# Access Compliance Report

## Public Rights-of-Way

### (Curb Ramps)

Intersection ID: 8131	Main Street: ORR_RD	Cross Street: UNIVERSITY_COMMERCIAL_PL	Location: SE
ADA ID: 7B731FC48749	Ramp Type: Perp	Initial Pass/Fail: Fail	Overall Compliance: No
Severity Score: 21.25			
Codes/Mitigation Info/Possible Solution		Field Measurements/Component Compliance

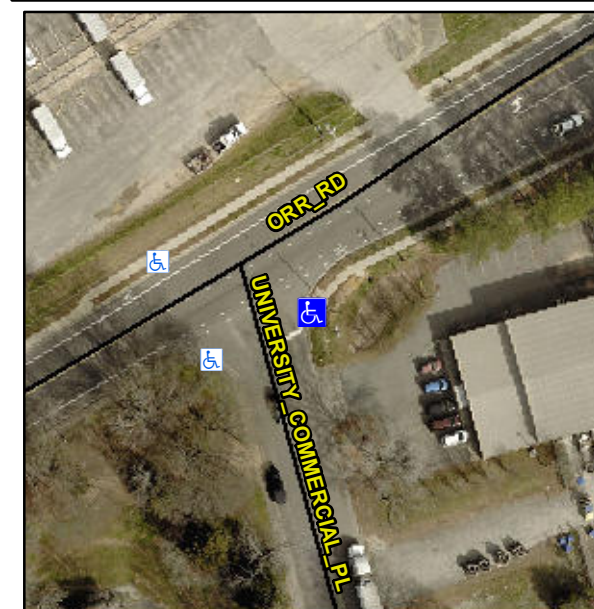
**Not Found, R304.5.1, R304.5.3**

Compliance	Description	Data	Compliance	Description	Data
N/A	Ramp Length (in)	47.0	Yes	Ramp Slope (%)	7.6
No	Ramp Width (in)	47.0	No	Ramp XSlope (%)	5.3
N/A	Flare Type LT	N/A	N/A	Flare Type RT	N/A
N/A	Flare Slope LT (%)	N/A	N/A	Flare Slope RT (%)	N/A
N/A	Flare Traversable LT?	N/A	N/A	Flare Traversable RT?	N/A
N/A	Landing Length (in)	N/A	N/A	DWS Provided?	N/A
N/A	Landing Width (in)	N/A	N/A	DWS Contrast?	N/A
N/A	Landing Slope (%)	N/A	N/A	DWS Length (in)	N/A
N/A	Landing X Slope (%)	N/A	N/A	DWS Full Width?	N/A
N/A	Landing Curb? (Y/N)	N/A	N/A	DWS Offset (in)	N/A
N/A	Shared Landing?	N/A			
N/A	Gutter Ponding?	N/A	N/A	Gutter Slope (%)	N/A
N/A	Gutter Lip Ht (in)	N/A	N/A	Gutter X Slope (%)	N/A
N/A	Painted X Walk1?	No	N/A	Painted X Walk2?	N/A
	X Walk 1 Direction	To W		X Walk 2 Direction	N/A
N/A	X Walk 1 Width (in)	N/A	N/A	X Walk 2 Width (in)	N/A
	X Walk 1 Slope (%)	1.7		X Walk 2 Slope (%)	N/A
	X Walk 1 X Slope (%)	2.3		X Walk 2 X Slope (%)	N/A

**Remove & Replace Entire Ramp.**
